CS Memorandum No. 1378

Subject: Configuration Management Board Meeting No. 115

CMB Meeting Minutes #115

SUBJECT: Configuration Management Board Meeting # 115 – Rev. No. 0

DETOUR SIGN PLAN
CENTRAL SUBWAY CONSTR
1252 - TUNNEL CONTRACT

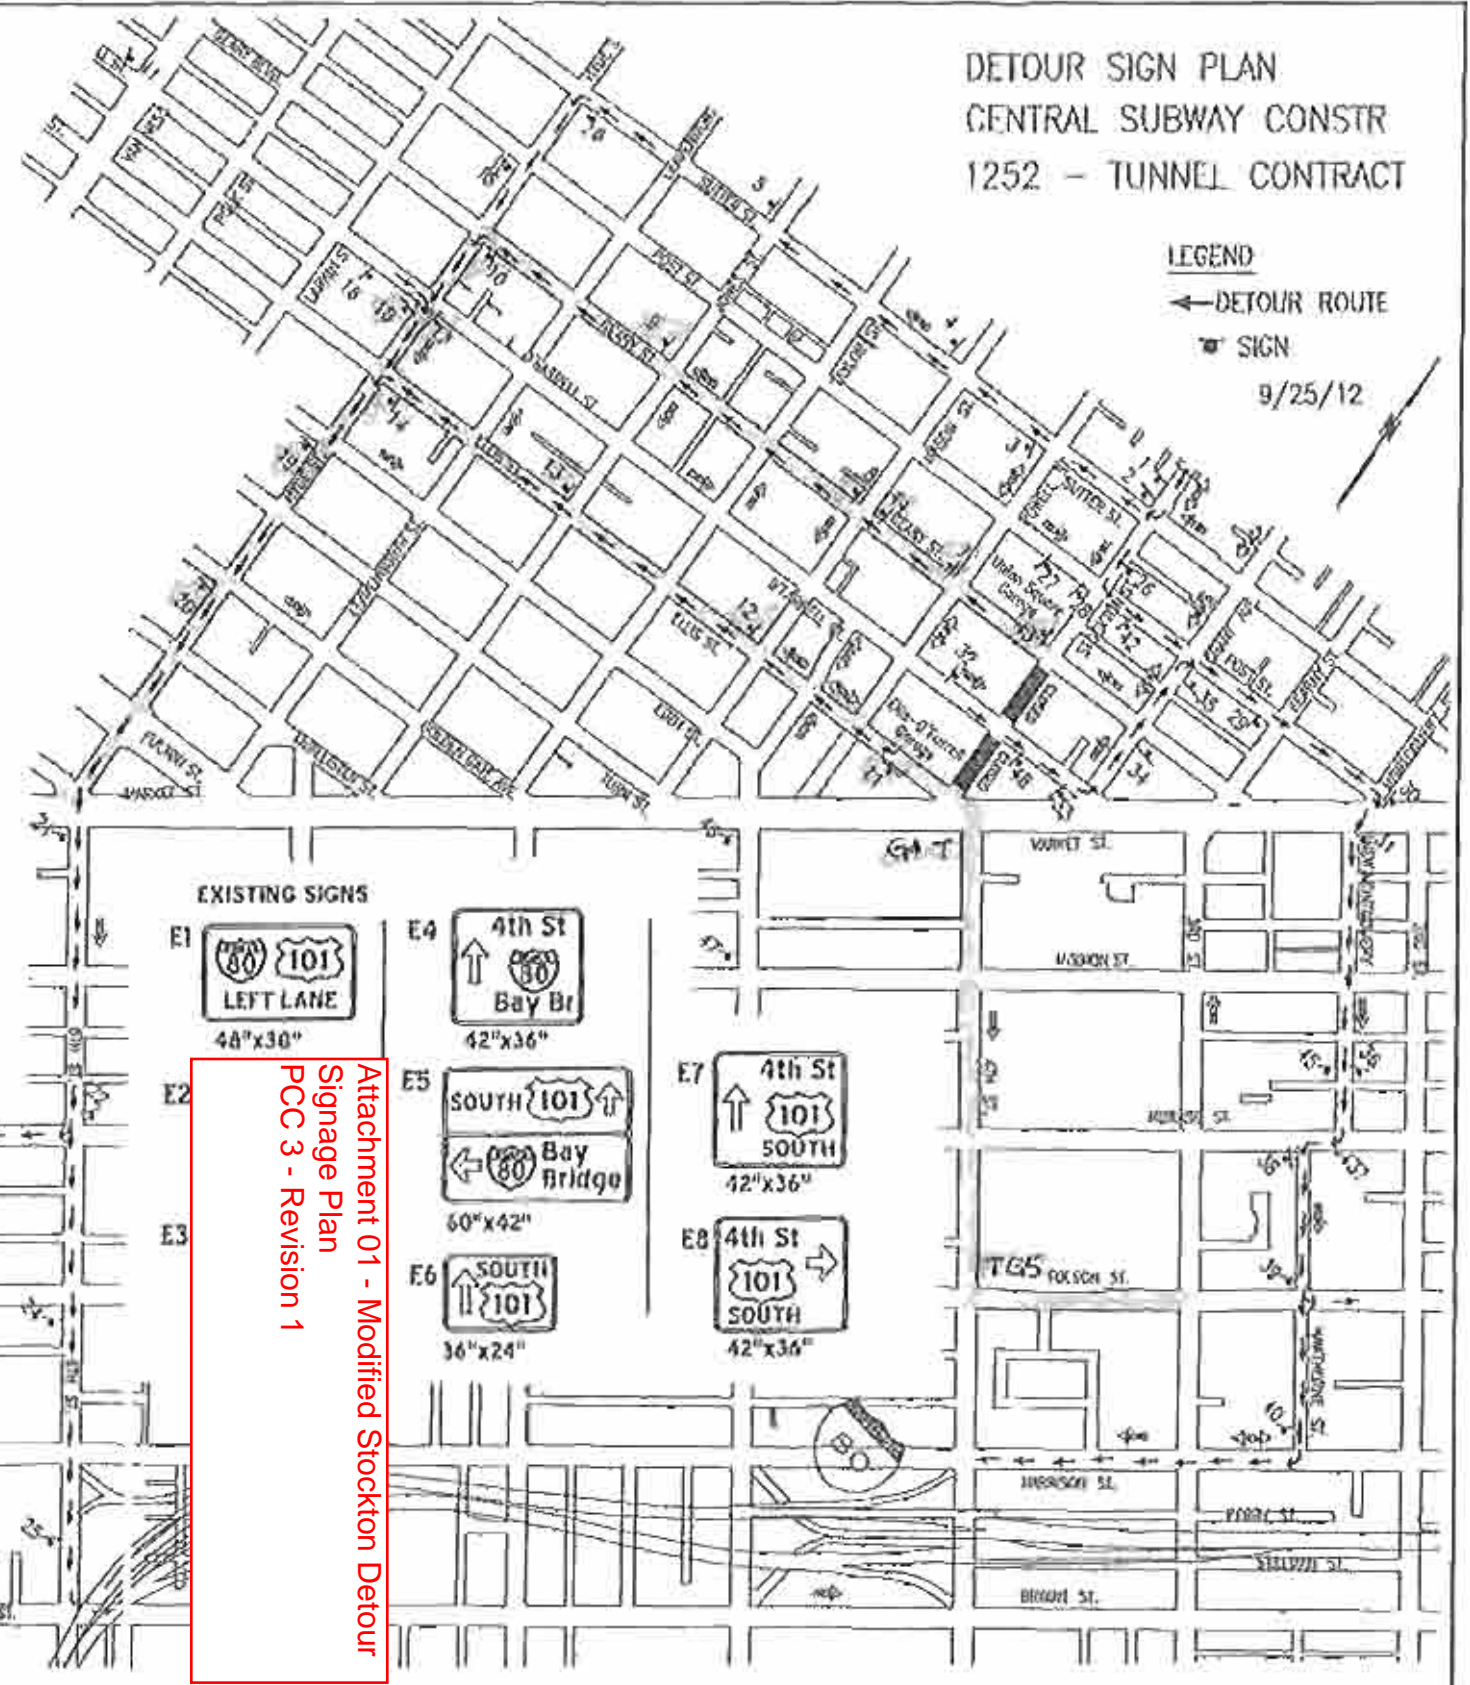
Full closure of Stockton Street at Union Square was not anticipated under the 1252 Contract. The implementation of detour signage associated with the full closure of Stockton Street was to occur under the 1300 Contract. After the award of the 1252 Contract it was decided that a full closure of Stockton could be implemented to help reduce the headwall construction durations. As a result of the full closure the City Traffic Engineer has requested that a portion of the 1300 detour signs be installed now under the 1252 Contract to help alleviate traffic congestion and provide better detour signage around Union Square. The remainder of the detour signage for Union square will be installed under the 1300 Contract. The following items listed below represent the reasons why the City Traffic Engineer has requested the installation of these detour signs now under the 1252 Contract:

- To encourage drivers trying to access Hwy 101 to continue along Ellis until Hyde St. For drivers trying to access the Bay Bridge, this change will have them cross Market St. from Ellis St. onto 4th St.

- SFMTA will work with the operator of the Ellis-O'Farrell Garage to encourage drivers to use the Ellis St. exit instead of the O'Farrell St. exit. Drivers that exit on O'Farrell will end up driving on Market if they are trying to go South of Market, but we are trying to not add traffic to Market Street.

See Attachment No. 01 - Modified Stockton Detour Signage Plan

| SHEET NO. | SK-1 |

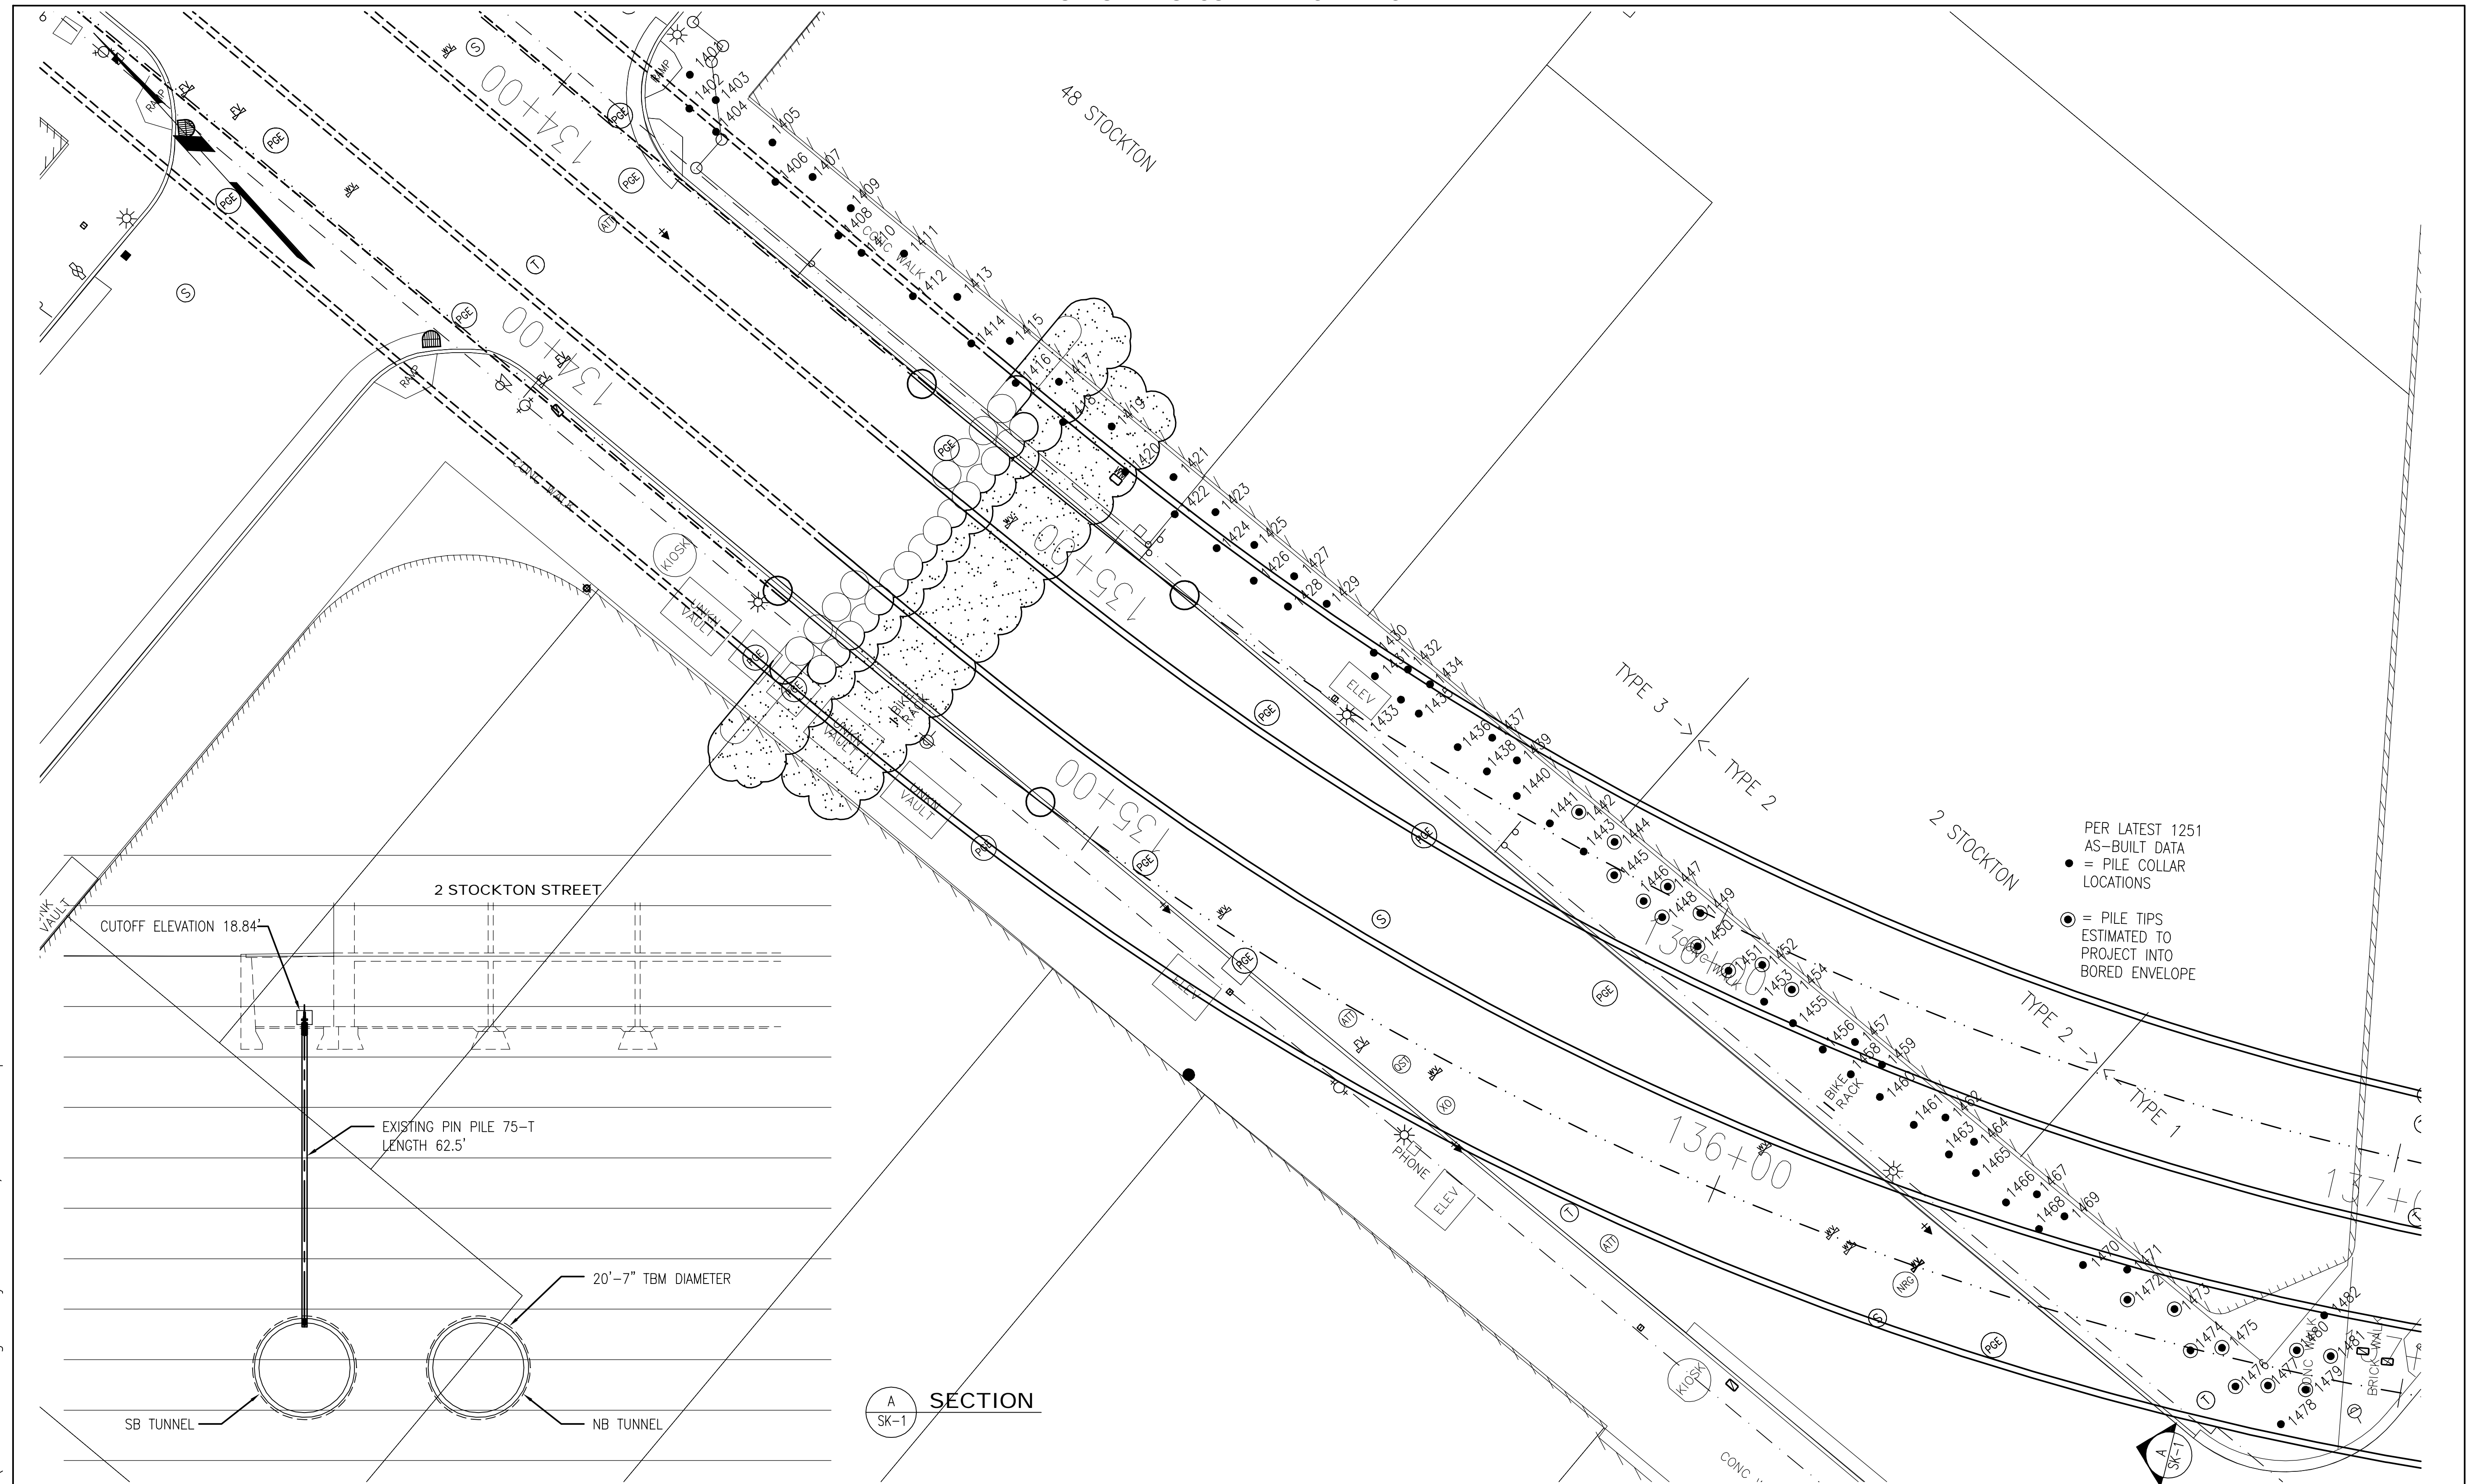
In response to SPM's Submittal 100.2, *Pile Cap Layout Elevations*, Design Lead Kenneth Ho (Structus), set top of Dwydag at 18.83' and top of pile cap/wall footing at 19'.

Cut-off on Matt's spread sheet and on the driller's Micro Pile Report is 18.84.

Worse case is 62.5' Dwydag at 18.84' elevation with end of pile at -43.66' – Matt's spread sheet shows the 20 piles, 9 SB and 11 NB and how much they project into the tunnel.

Drill Tech's approved as noted Submittal 100.4, included the following comment from the Designer, "Max pile lengths not shown. Revise to include max pile lengths."

Pile Cap Layout Elevations

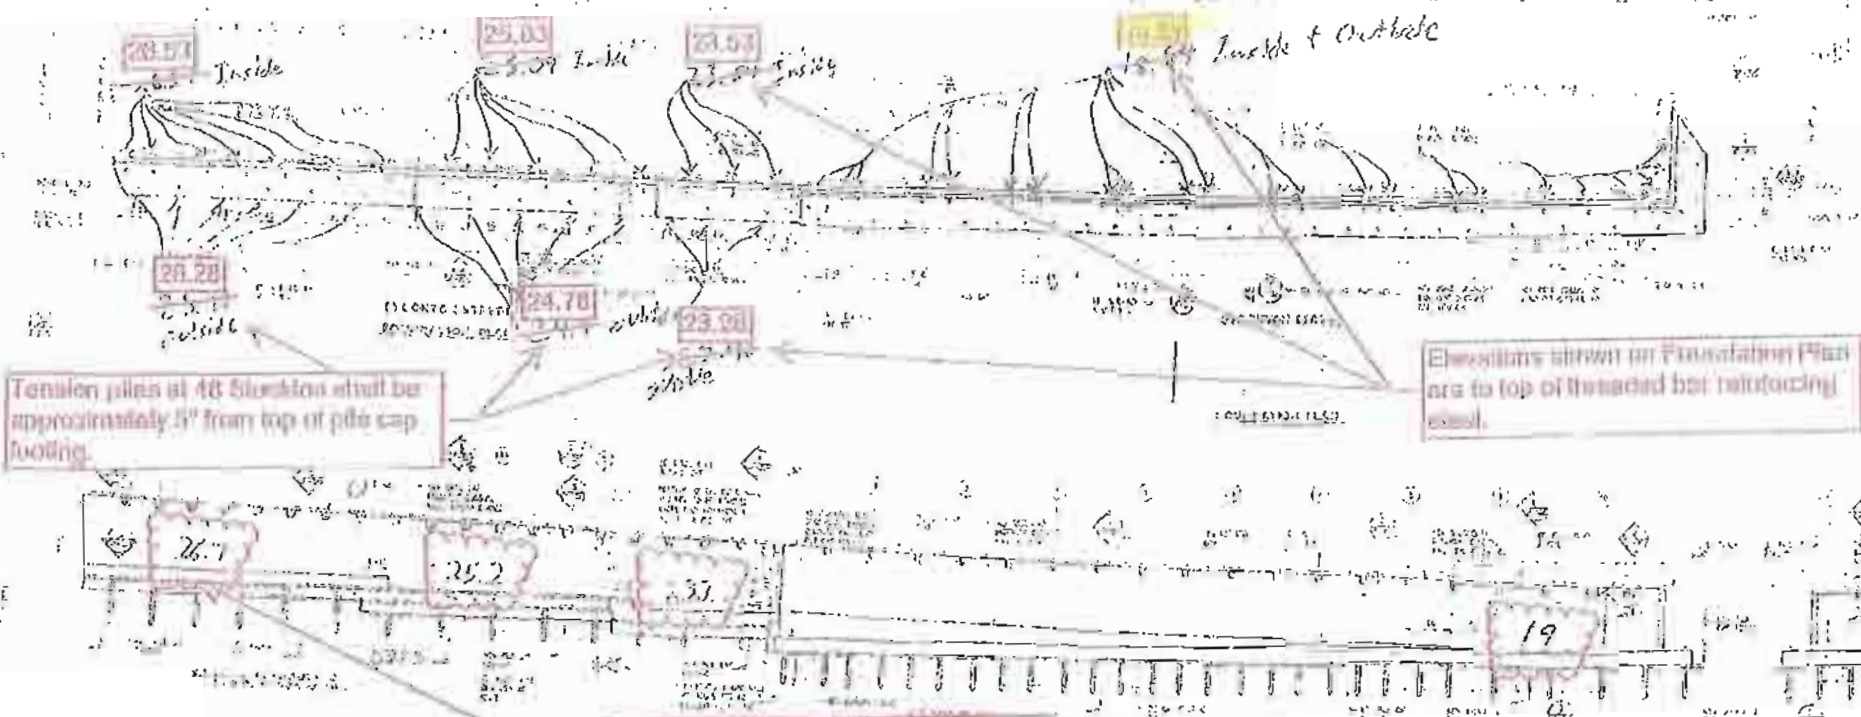
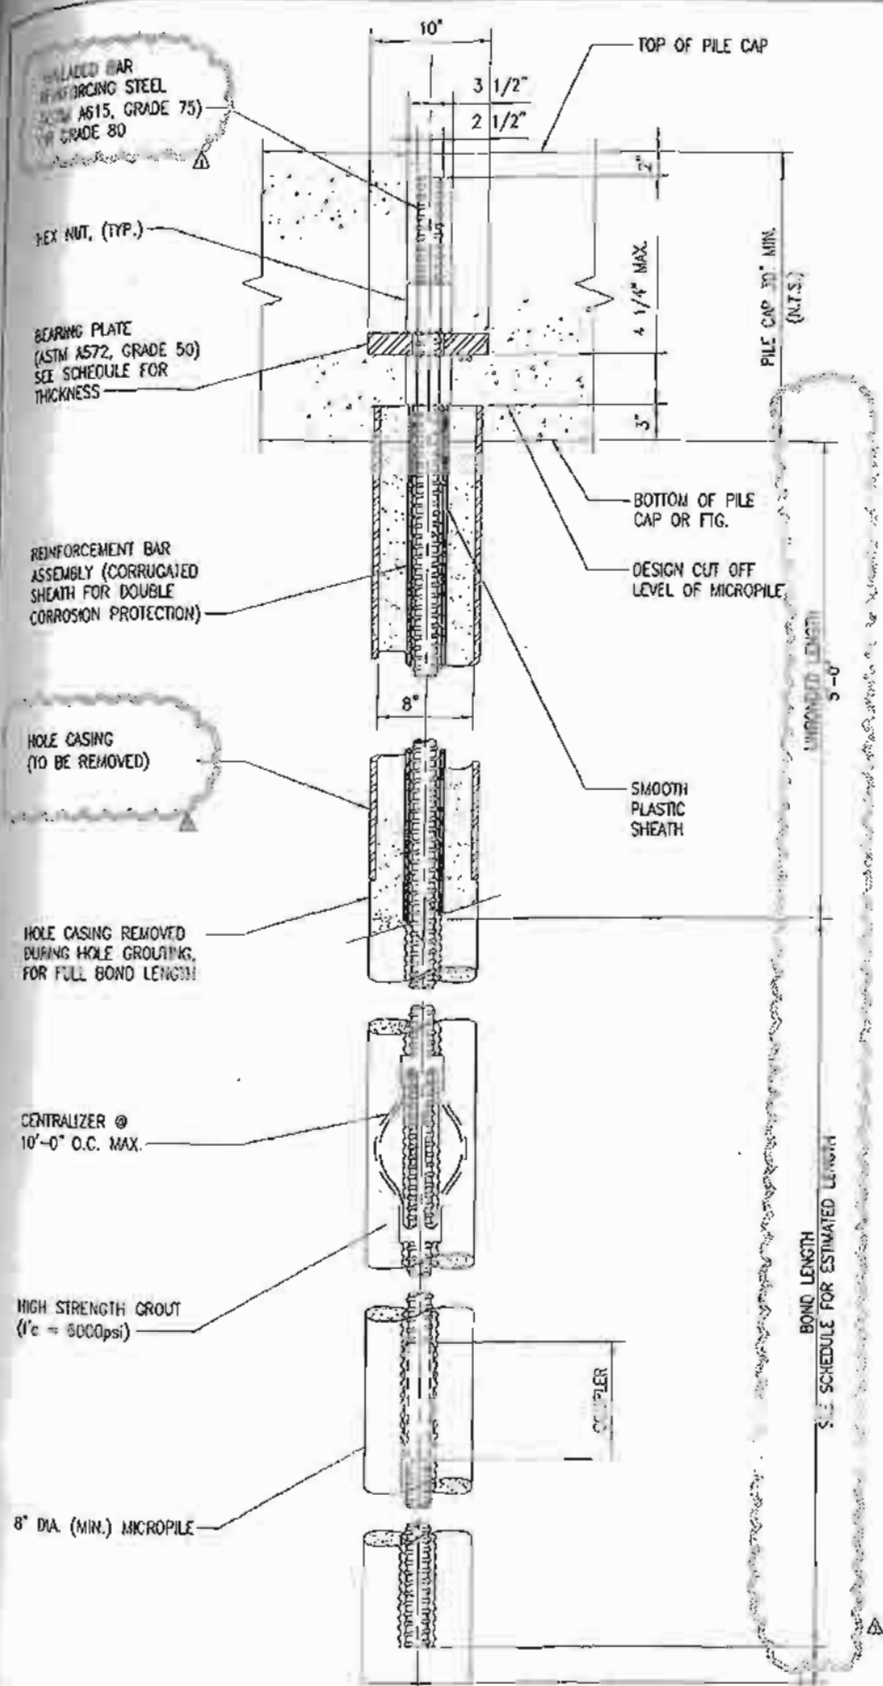
Tension piles at A6 Station shall be approximately 5' from top of pile cap footing.

Elevations shown on Foundation Plan are to top of finished bar reinforcing.

Contractor shall confirm in field elevations shown shall not exceed max. heights indicated on detail 3/ 84-400 for various Wall Types.

Elevations shall be confirmed and coordinated to not interfere with proposed Joint Trench.
